ARCHITECTURAL DESIGN STATEMENT ADDENDUM

Prepared in response to DPHI request for further information dated 16 February 2026.

16-24 LORD STREET & ROSEVILLE 21-27 ROSEVILLE AVENUE

MARCH 2026

FIGURE 2.4

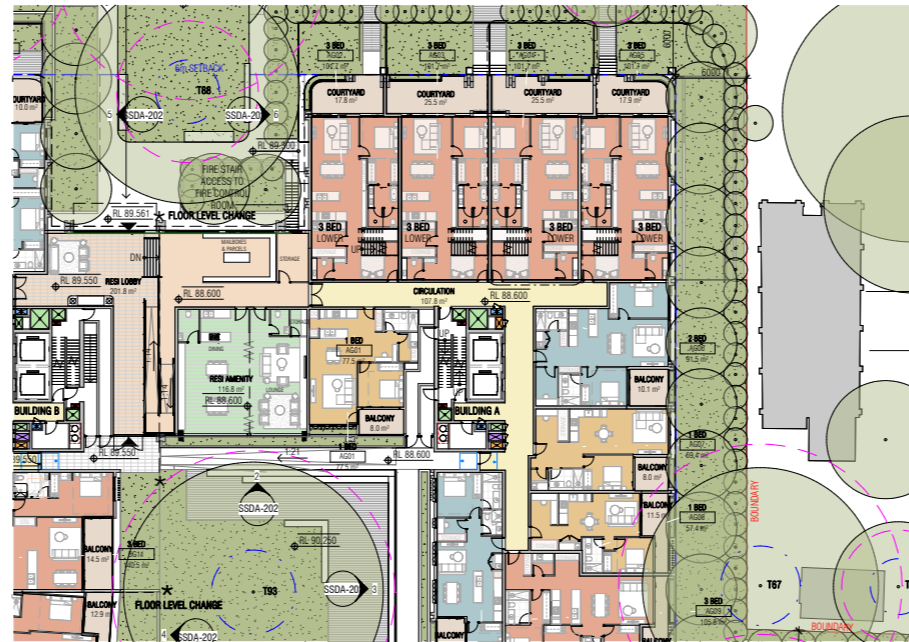
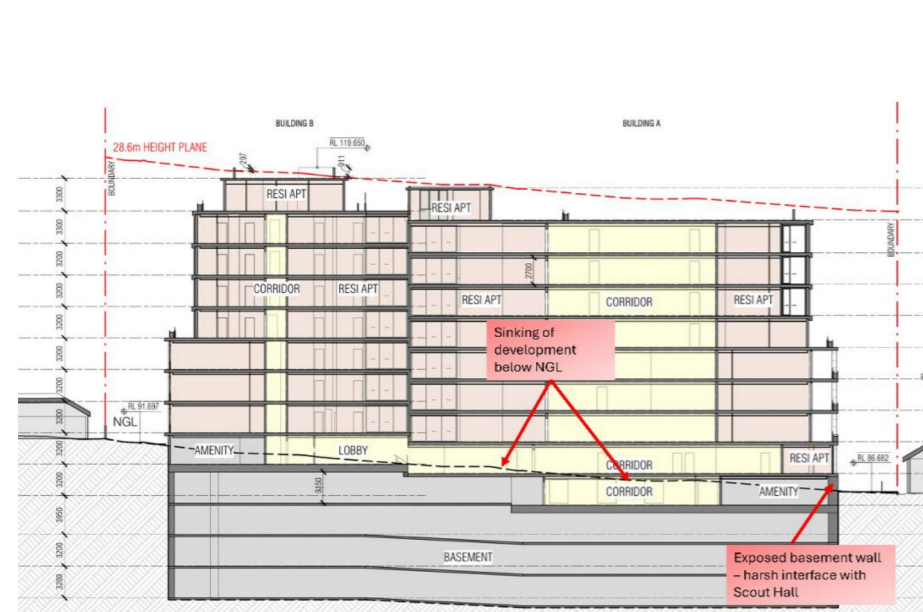
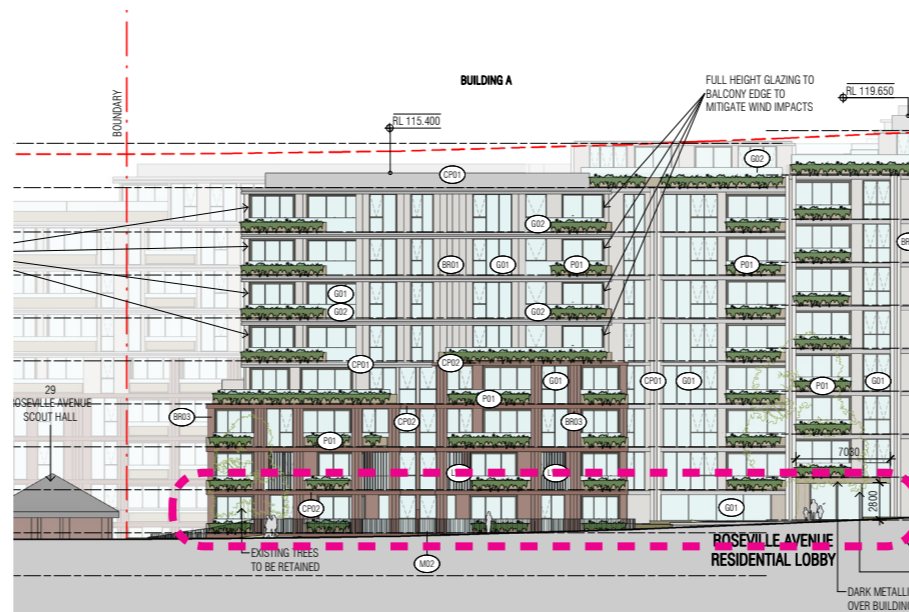
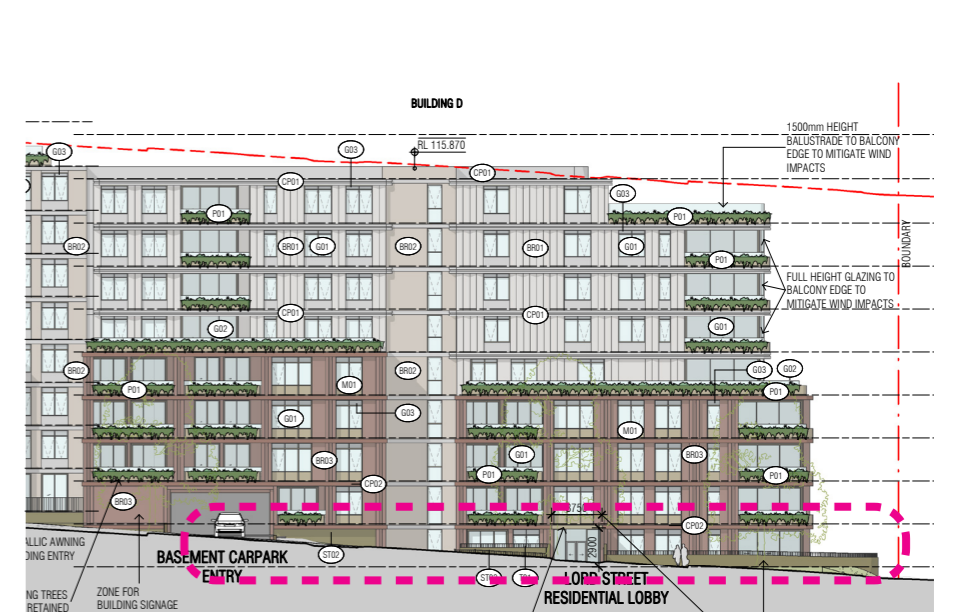
2.4 Council's comments suggest that the building has been dropped to ensure that the building height does not project above the permissible building height plane. This is incorrect, and given the flood planning levels that apply to Buildings A and D would not be possible. Habitable floorspace in these buildings is entirely above ground level. Storage, car parking and residential amenities are located below ground.
